ADDENDUM

PROJECT: University of South Dakota
Patterson Hall
Mechanical / Electrical Infrastructure Upgrades
Vermillion, South Dakota

AD-2

DATE ISSUED: Thursday, January 29, 2015

From Sheet: **C-101** for CA use:
Drawing # **C-101.1**

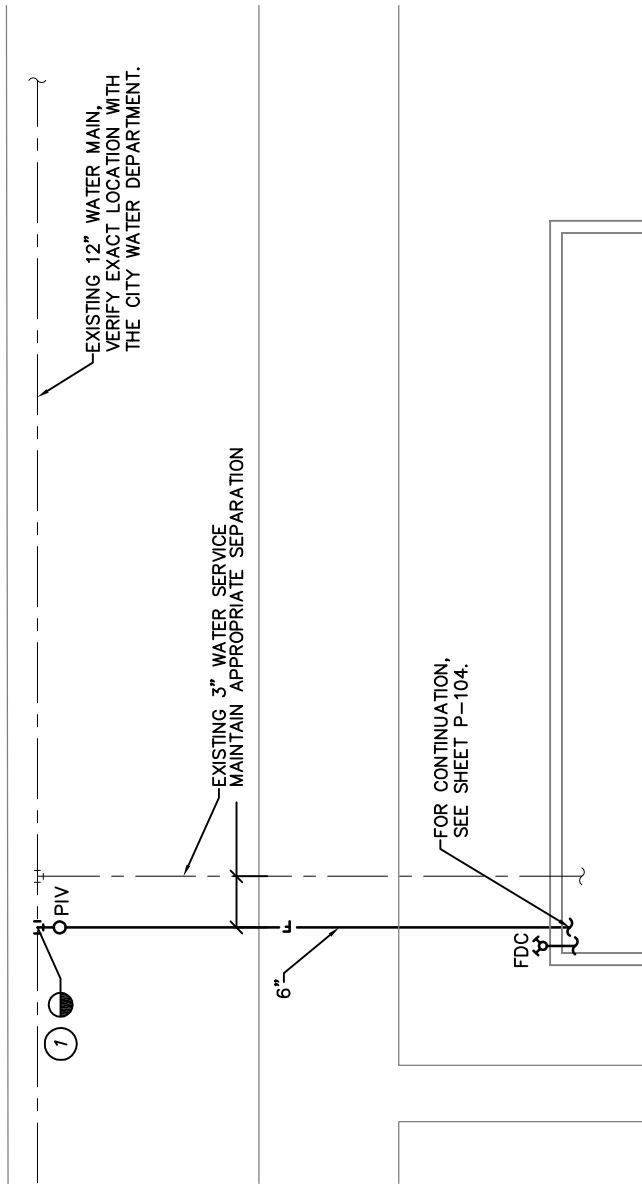
In reference to Sheet C-101, see attached Supplemental Drawing C-101.1 for additional notes regarding start of exterior utility work.

Drawing # P-105.1

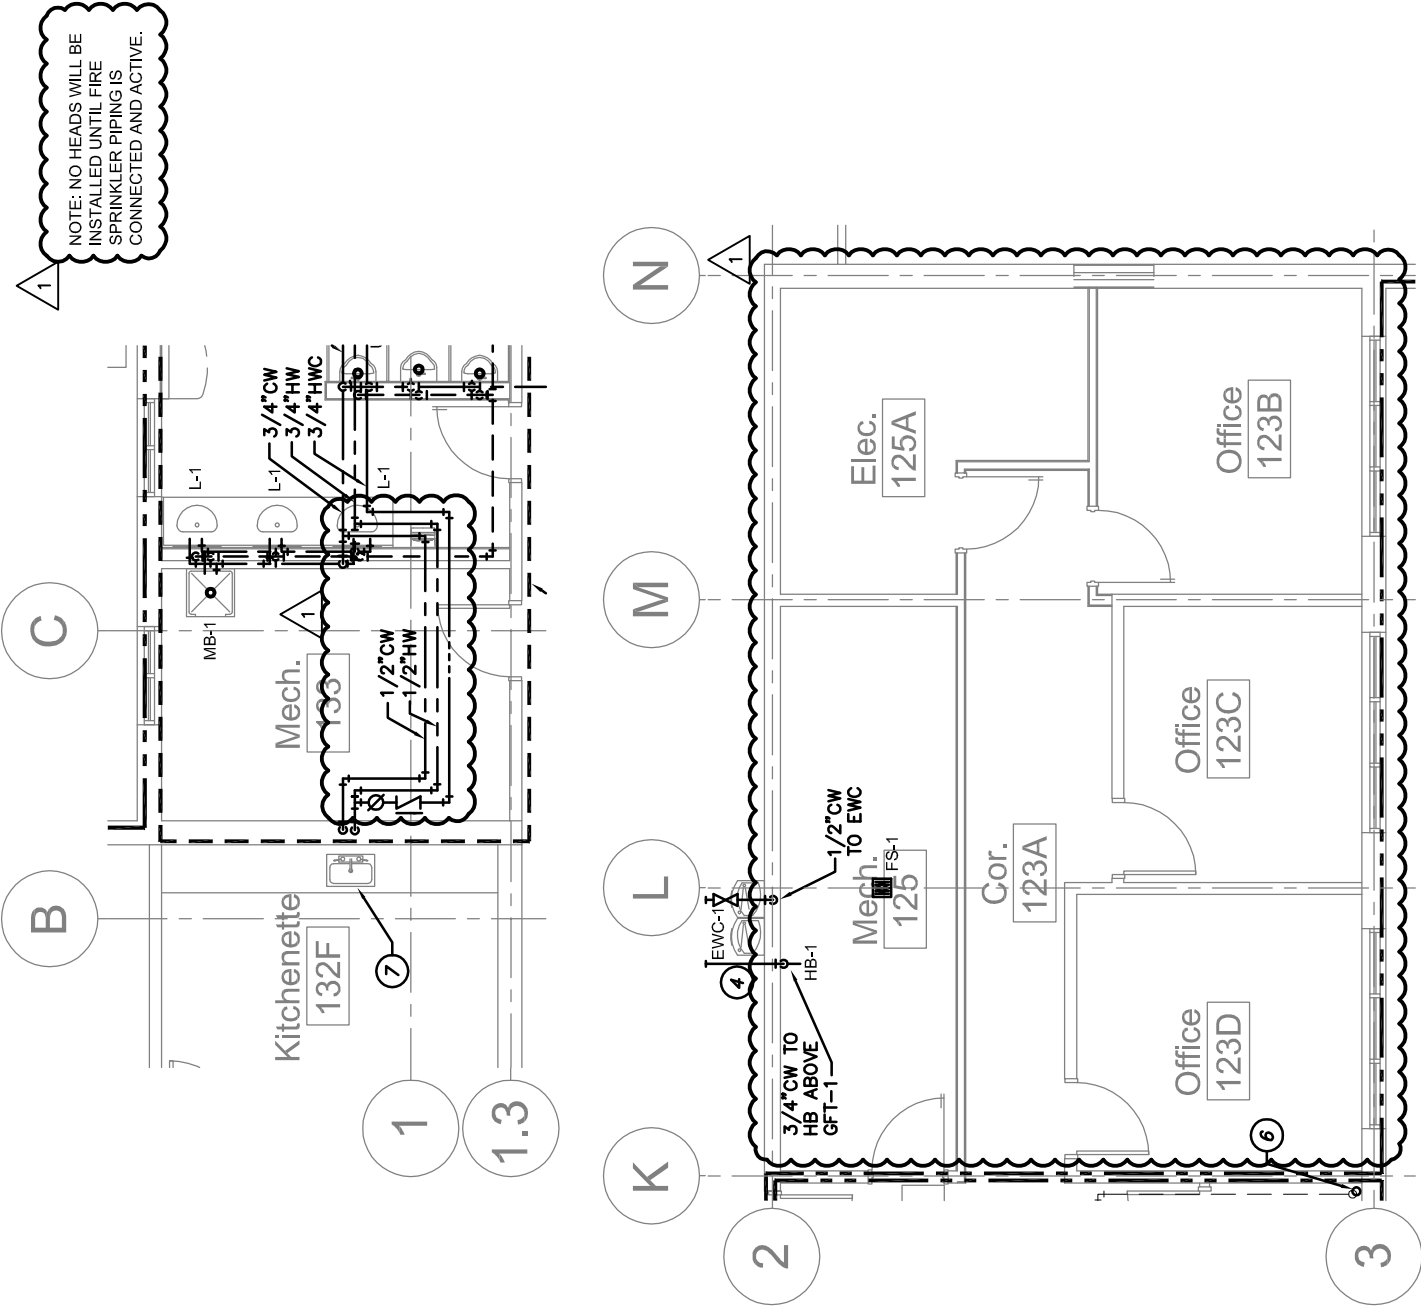
In reference to Sheet P-105, refer to attached Supplemental Drawing P-105.1 for an additional general note, floor plan update and rerouting of piping in Mechanical 133 to avoid the panels.

From Sheet: P-106 for CA use:
Drawing # P-106.1

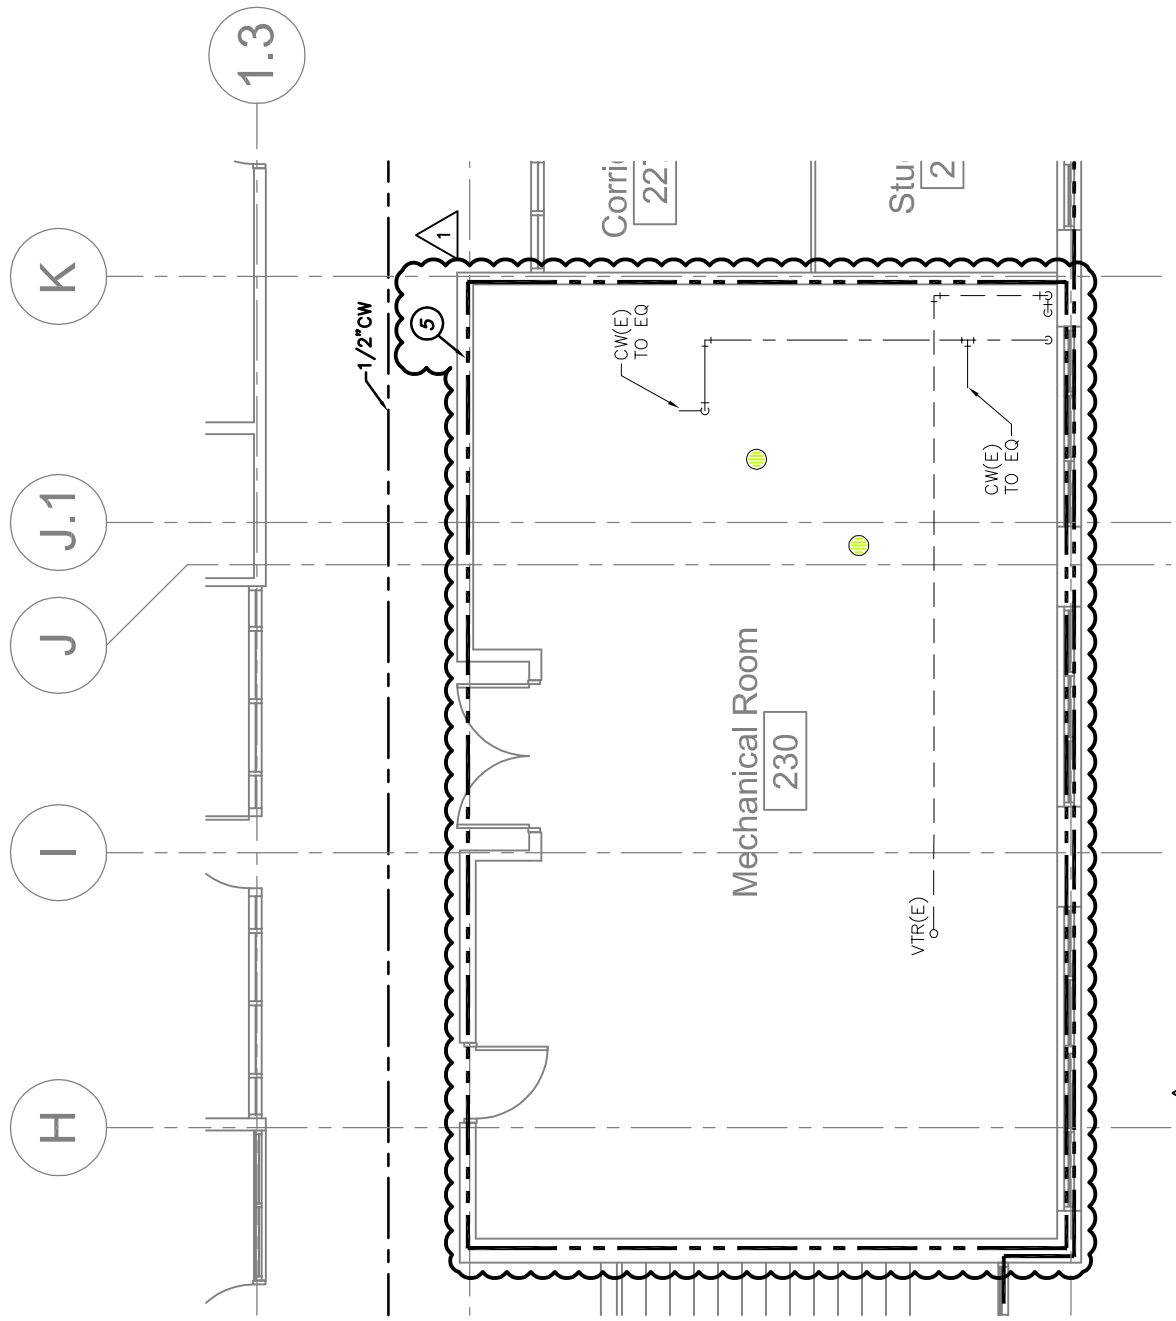
In reference to Sheet P-106, refer to attached Supplemental Drawing P-106.1 for an additional general note and changes to the fire sprinkler work in Mechanical Room 230.

M-105

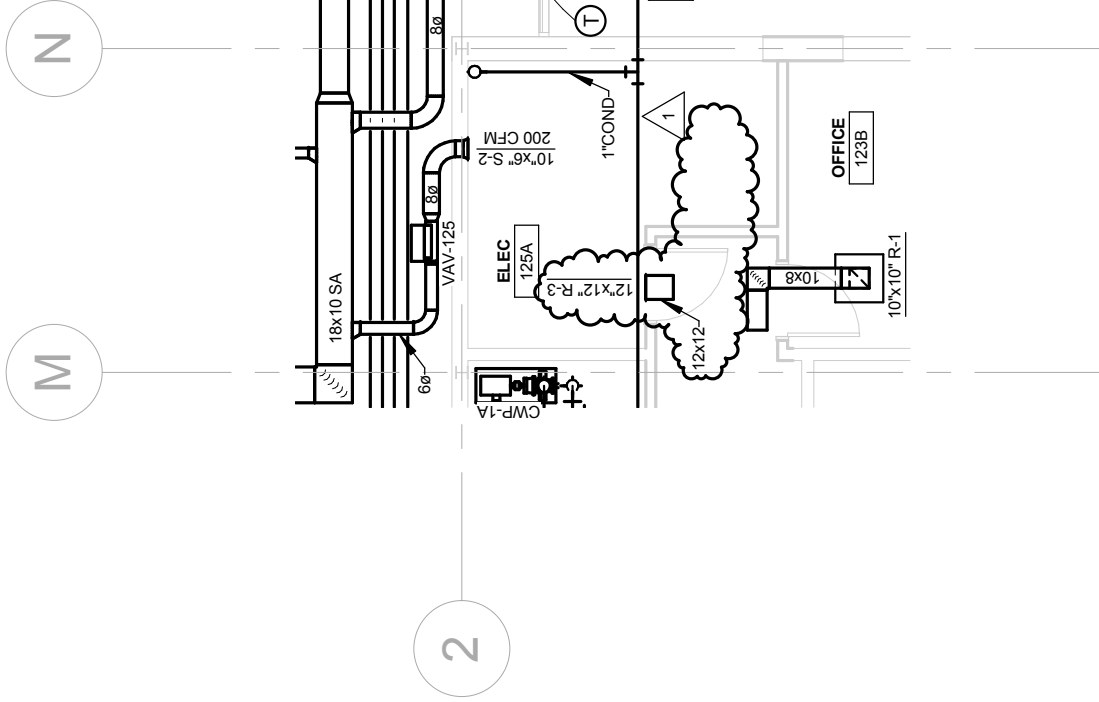
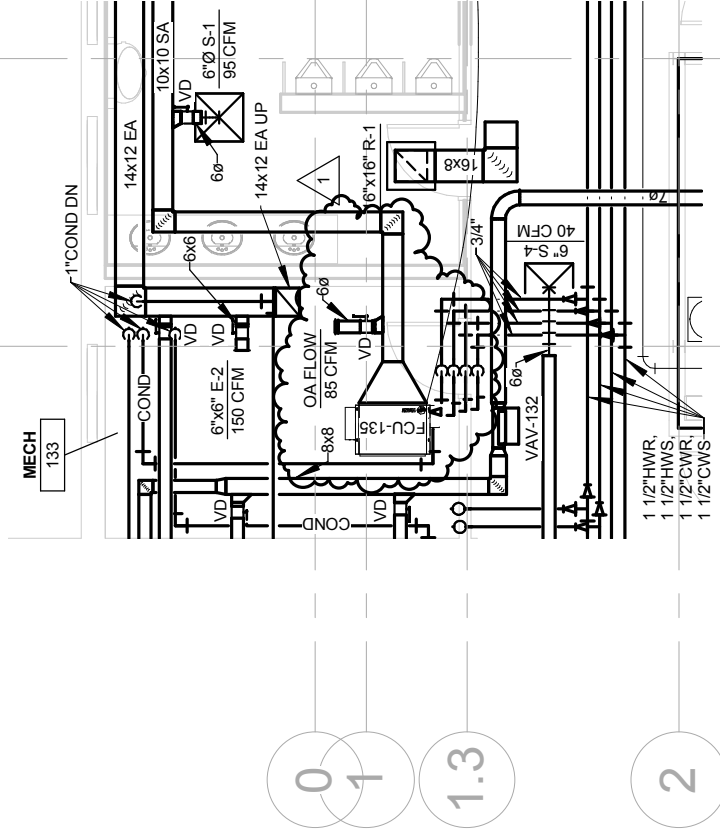
In reference to Sheet M-105, refer to attached Supplemental Drawing M-105.1, for relocation of transfer grille in Electrical 125A.

From Sheet: **E-601** for CA use:
 Drawing # **E-601.1**

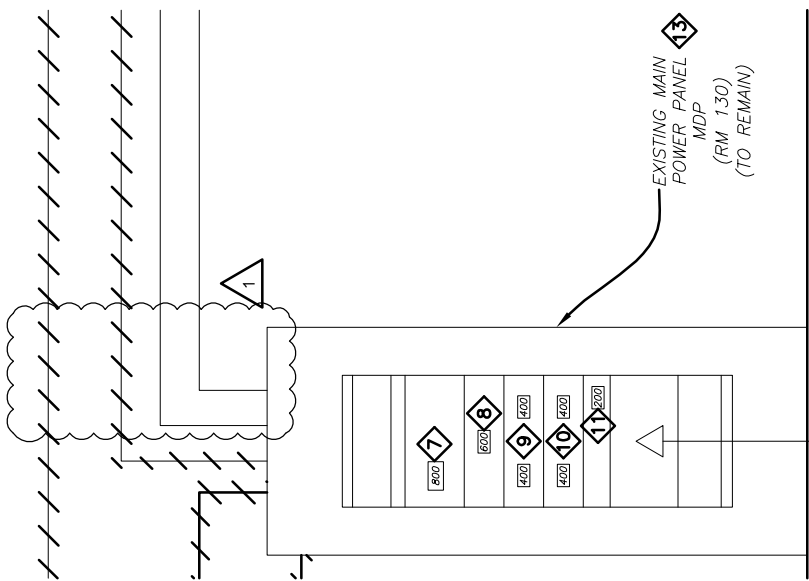
In reference to Sheet E-601, Electrical Riser Diagrams: see attached revised sheets E-601.1, E-601.2, and E-601.3.

- 1 EXISTING 600 AMP BREAKER IN EXISTING PANEL 'MDP' CURRENTLY FEEDING PANEL 'MSB' TO BE REPLACED WITH 800 AMP BREAKER TO FEED 'DPI'.
- 9 EXISTING 400 AMP BREAKER FEEDING 'NDP' TO FEED 'L1' REMOVE SPARE 400 AMP BREAKER AND REPLACE WITH BLANK COVER.
- 10 EXISTING 400 AMP BREAKERS FEEDING '124' AND '128' TO REMAIN.
- 11 EXISTING 200 AMP BREAKER TO FEED NEW PANEL 'L2'.
- 12 EXISTING FEEDER FOR '122' MAY BE RE-USED. EXTEND CONDUIT AND CONDUCTORS AS REQUIRED.
